# VAUGHAN Staff Report Summary

<b>File:</b> A041/20

165 Boone Cr Kleinburg Address:

### Minor Variance Application

LEFT SIDE UPGRADE ELEVATION 'A'

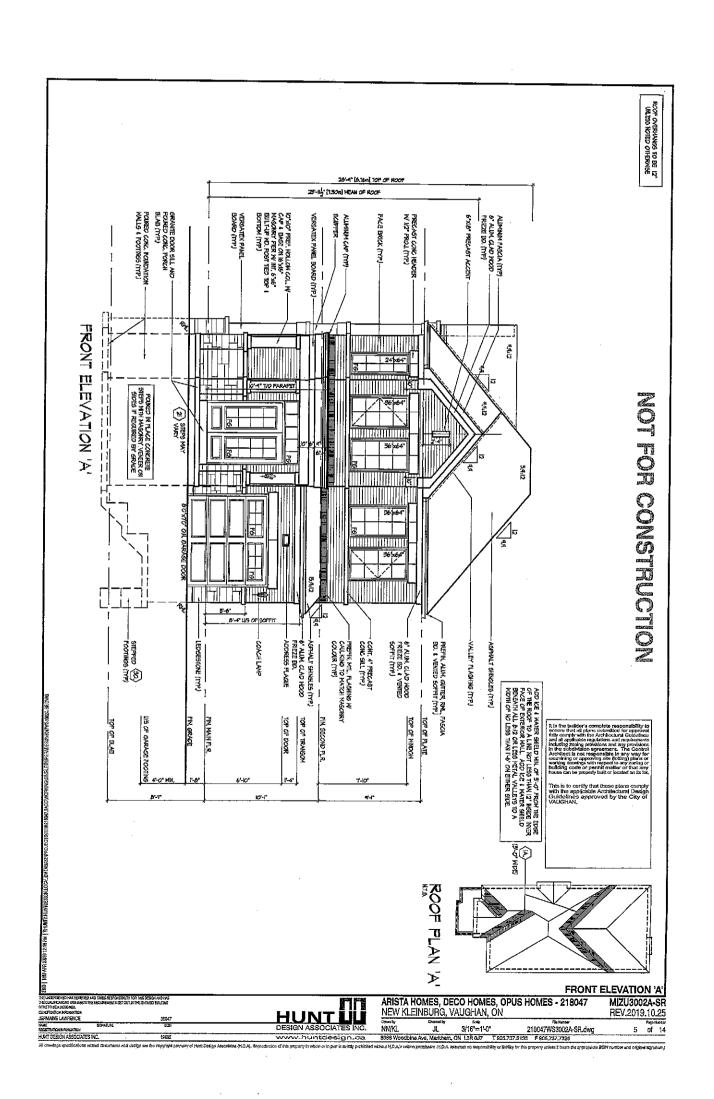
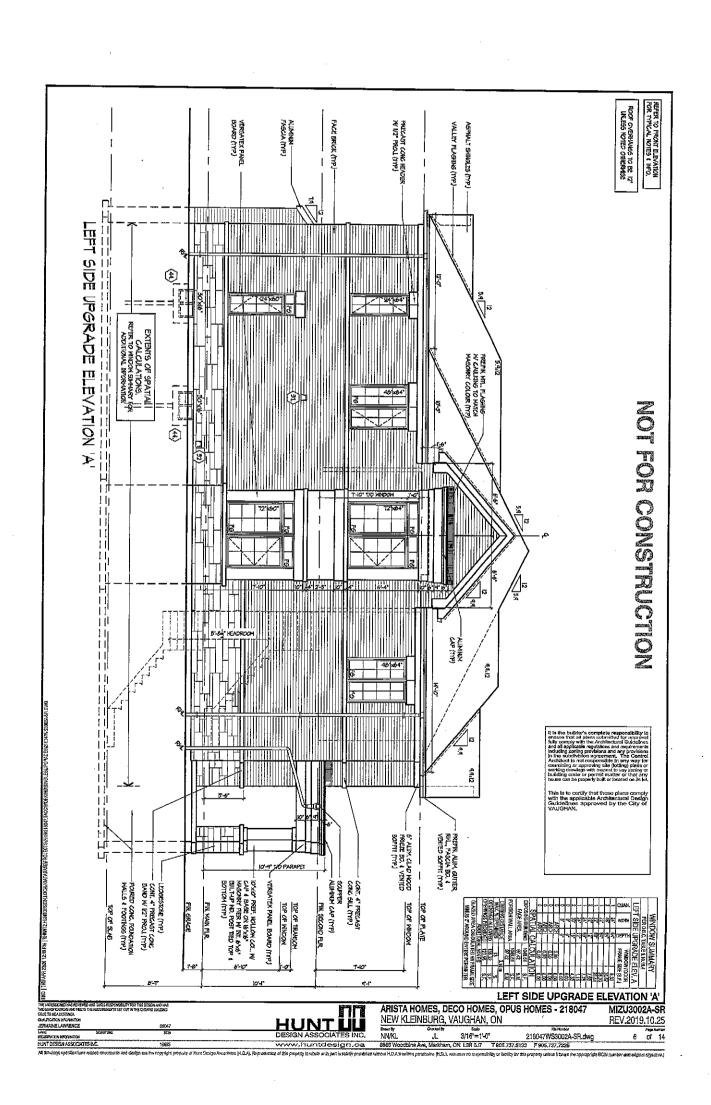
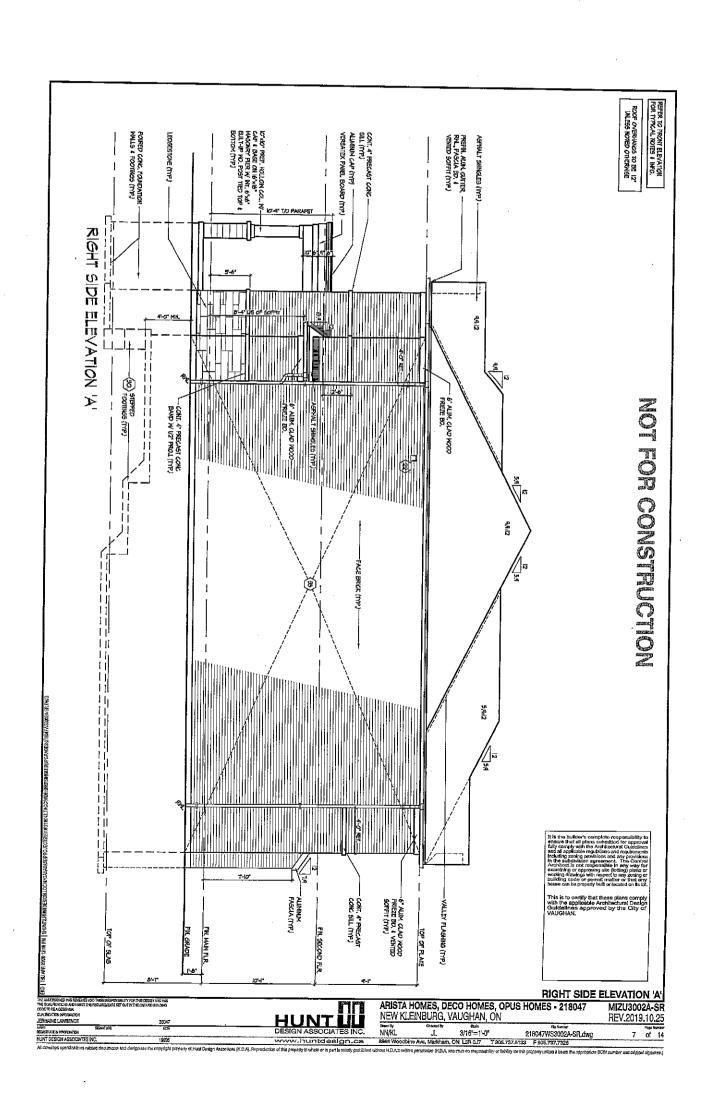
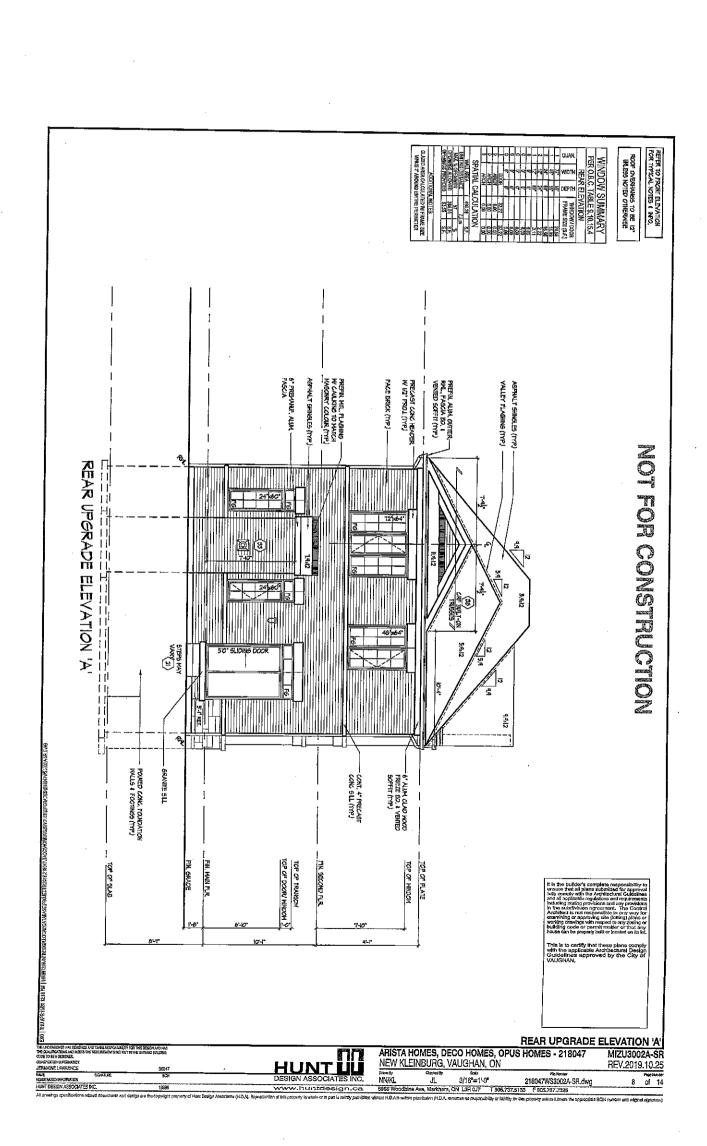
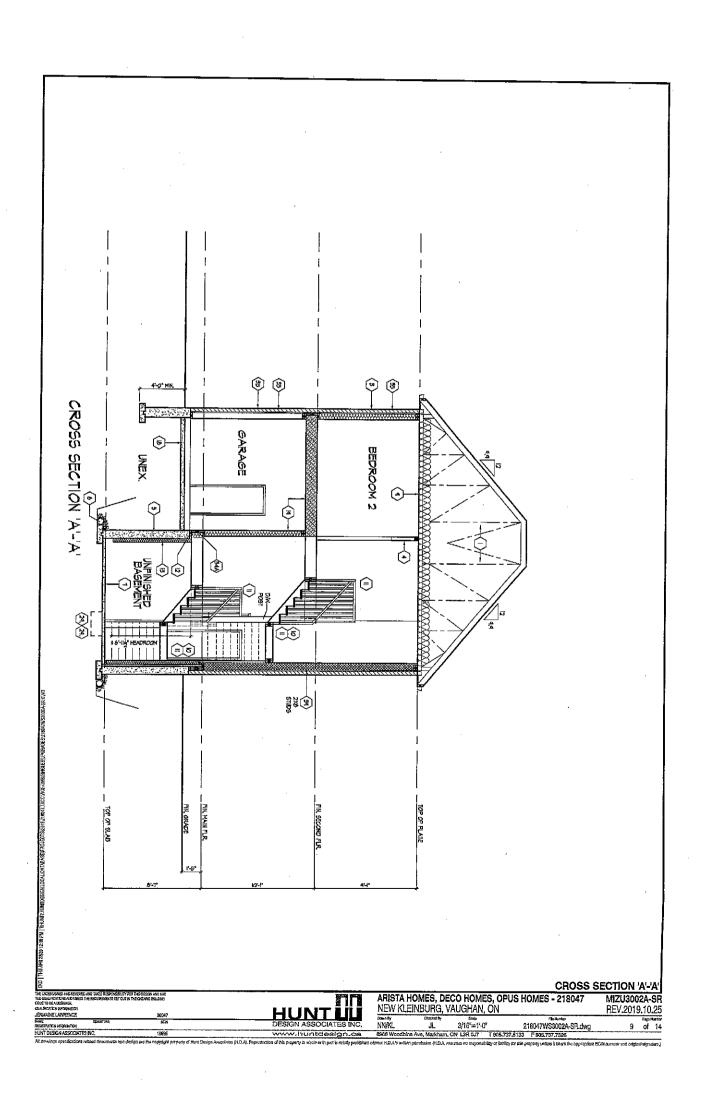
Applicant has advised that they cannot comply with By-law for the following reason(s): Bay window/box out encroachment of 0.32m adjacent to future walkway block is proposed whereas 0m encroachment is required per by-law setback to be 3.18m

The projection of the bay window into the required interior side yard is minimal and is has no adverse impacts on the adjacent walkway. Accordingly, the Development Planning Department is of the opinion that the proposal is minor in nature, maintains the general intent and purpose of the Official Plan and Zoning By-law, and is desirable for the appropriate development of the land.

The Development Planning Department recommends approval of the application.
